Paso Basin Cooperative Committee Notice of Regular Meeting

RE: Approved Determination of the Revised Groundwater Sustainability Plan Submitted for the Salinas Valley – Paso Robles Area Subbasin

**STATEMENT OF FINDINGS REGARDING THE
APPROVAL OF THE
SALINAS VALLEY – PASO ROBLES AREA SUBBASIN
GROUNDWATER SUSTAINABILITY PLAN**

State of California
Department of Water Resources
Sustainable Groundwater Management Program
Groundwater Sustainability Plan Assessment
Staff Report

Figure 1: Locations of interconnection between groundwater and surface water.

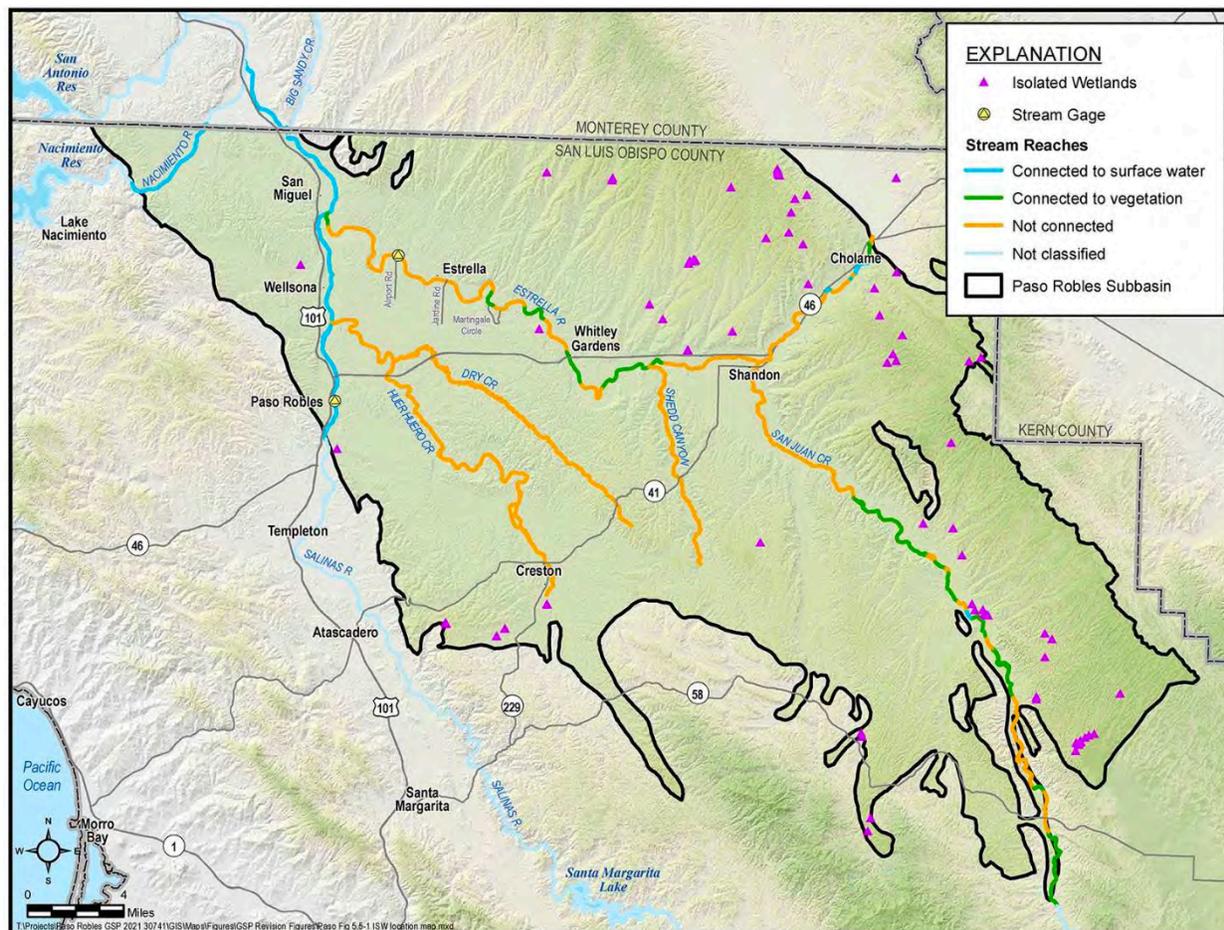
Staff consider the revised Plan to be generally improved but still missing information that should be included to improve clarity and completeness in addressing the GSP Regulations and facilitate staff evaluations of GSP and subsequent periodic evaluations. The Plan notes that pumping from the Alluvial Aquifer is “rare”, generally occurs to meet domestic and limited livestock water demands, and large-scale irrigation pumping does not typically occur.⁵¹ However, the GSP also states that the agricultural water use sector—which is the largest by volume⁵² with production wells located along the Salinas and Estrella Rivers⁵³—also pumps from the Alluvial Aquifer⁵⁴ without quantifying that volume. The GSP should provide specific volumetric quantities of estimated pumping that

occurs from the Alluvial Aquifer to detail the comparison of pumping from the Subbasin's two principal aquifers. Staff require this supporting information to assess whether the establishment of management criteria, which relies heavily on the claim that most groundwater pumping is from the Paso Robles Formation Aquifer, is a reasonable assumption. Additionally, while the GSP states analysis from *Methodology for Identifying Groundwater Dependent Ecosystems* indicates that groundwater pumping from the Paso Robles Formation Aquifer does not materially impact relevant groundwater dependent animals in Salinas River flows, the GSP does not discuss potential impacts of pumping from the Alluvial Aquifer on southern steelhead which migrate up and down the Salinas River in winter and spring. Department staff recommend the GSAs provide clear explanation of the usage of the Alluvial Aquifer and provide specific volumetric quantities of estimated pumping that occurs from the Alluvial Aquifer to detail the comparison of pumping from the Subbasin's two principal aquifers. (see [Recommend Corrective Action 4a](#)).
